Re: SECURED BY DESIGN (SBD) – Building 401, Avro Way, Manchester.

Secured by Design Checklist

2021/0529/SBD/01
Building 401, Avro Way, Manchester

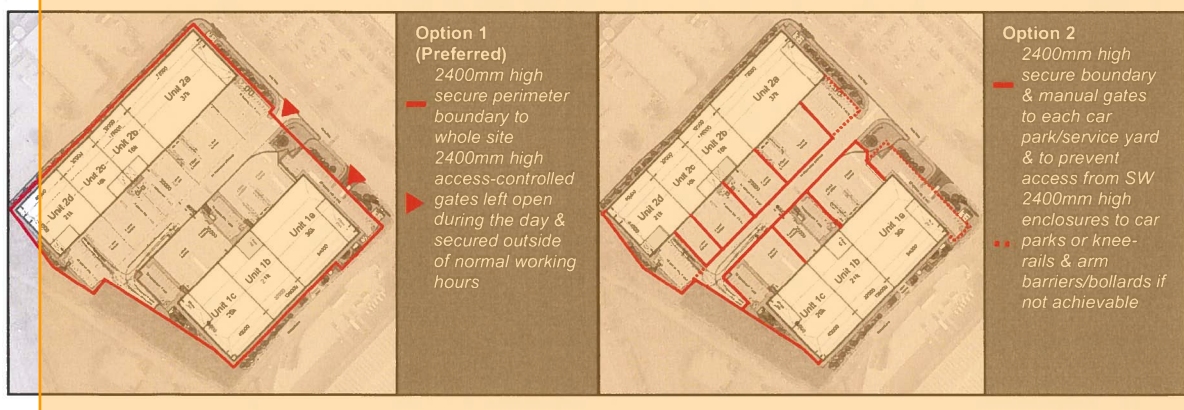
- ☐ **A monitored alarm system should be installed to each unit, linked to contacts on all external doors/shutters and PIR detectors covering all ground floor areas with windows, with a signal terminating at a recognized Alarm Receiving Centre (ARC) or security control room.**
